PAINT BRUSH HILLS PUMP HOUSE
 GRADING PLAN AND EROSION CONTROL PLAN
 prepared for
PAINT BRUSH HILLS METROPOLITAN DISTRICT

DRAWN BY:	DESIGNED BY:
JOB NUMBER: 1070.0010	DATE: MARCH, 2019
SCALE: 1"=10'	DRAWING NAME:
SHEET NO: 5	of 8

Subject: Callout
Page Label: [1] grading and erosion control plan
Author: dsdlaforce
Date: 5/6/2019 1:39:13 PM
Color: ■

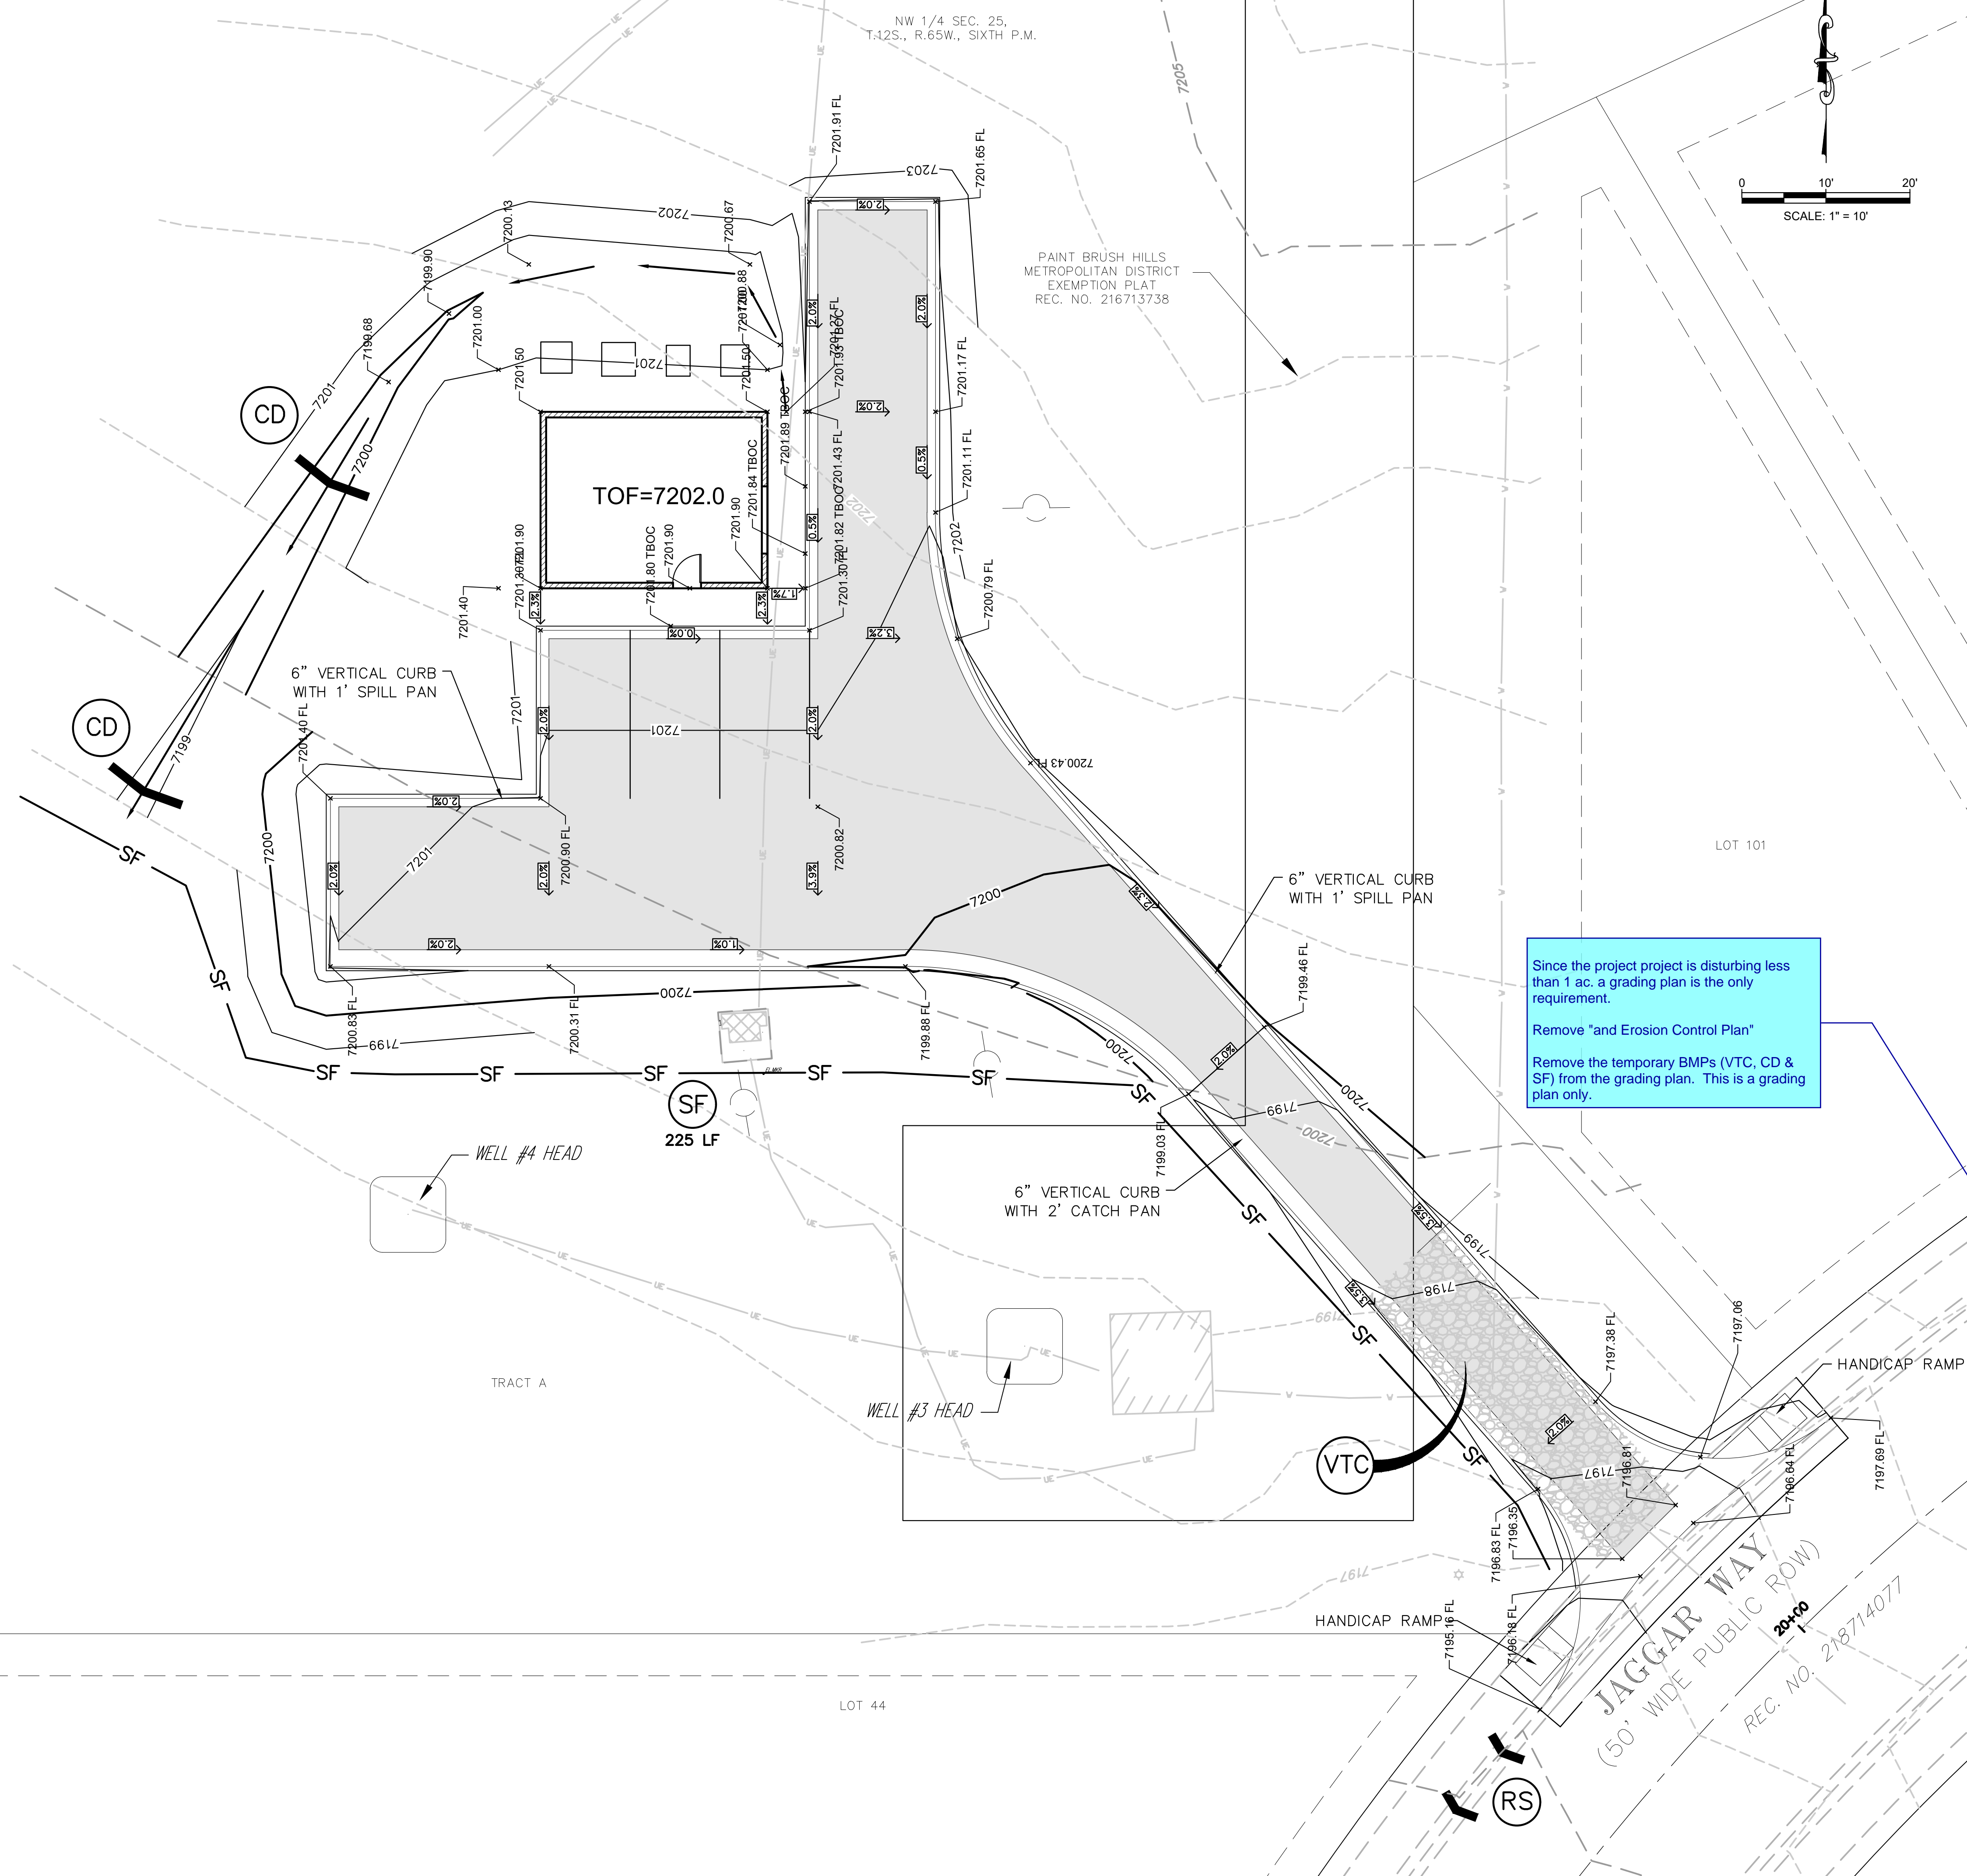
Since the project project is disturbing less than 1 ac, a grading plan is the only requirement.
 Remove "and Erosion Control Plan"
 Remove the temporary BMPs (VTC, CD & SF) from the grading plan. This is a grading plan only.
